HISTORIC AND DESIGN REVIEW COMMISSION

HDRC CASE NO: 2016-197
ADDRESS: 2042 W GRAMERCY PLACE
LEGAL DESCRIPTION: NCB 1933 BLK 31 LOT 18
ZONING: R6 H
CITY COUNCIL DIST.: 7
DISTRICT: Monticello Park Historic District
APPLICANT: Thomas Bergo
OWNER: Thomas Bergo
TYPE OF WORK: Addition, Window replacement, window trim
REQUEST:

2042 W. Gramercy Place – Addition Request

5a

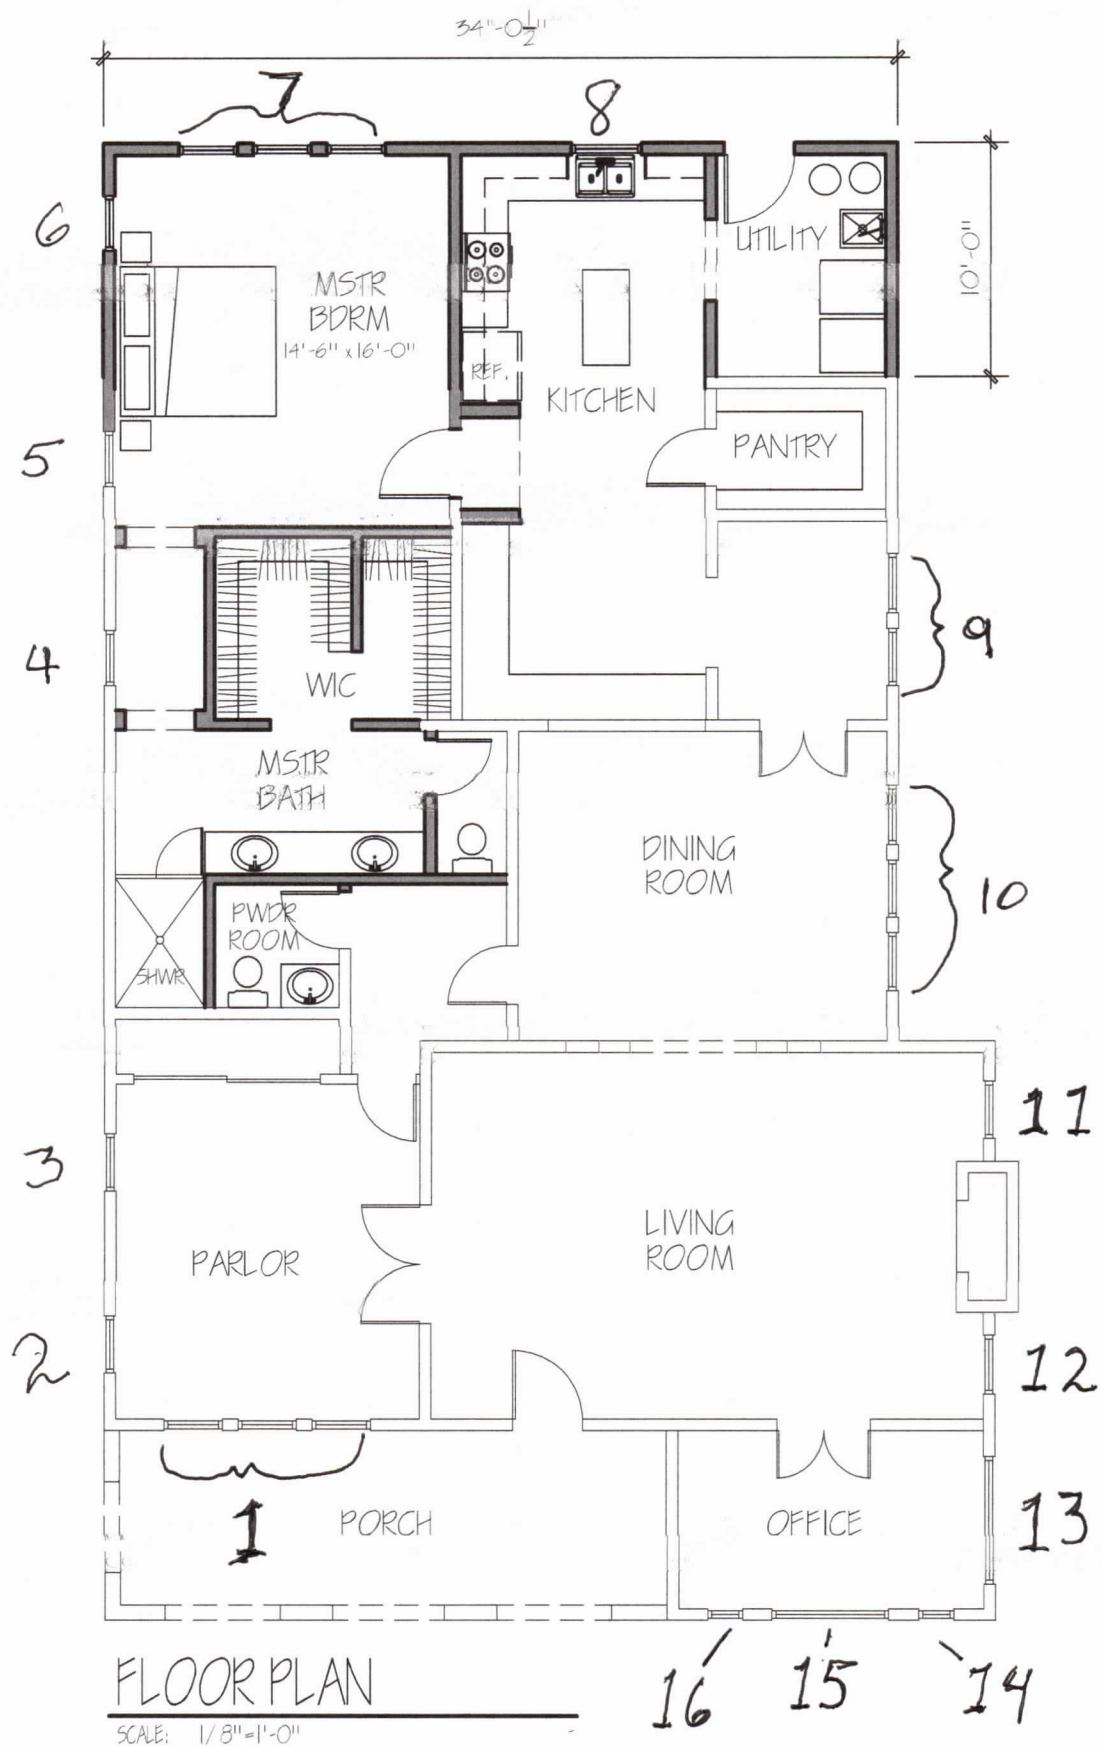
- g. **ARCHITECTURAL DETAILS** – On the rear façade, the application is proposing to install a triple window, with three six over six wooden windows. There will also be a square 6 over 6 wood window and a sliding glass door. According to the Guidelines for Additions 4.A.ii., architectural details that are in keeping with the historic structure should be featured throughout the addition. Staff finds the window proportion not appropriate for the style of the home.

Staff recommends approval of items #1 through 4 as submitted based on findings a through j.
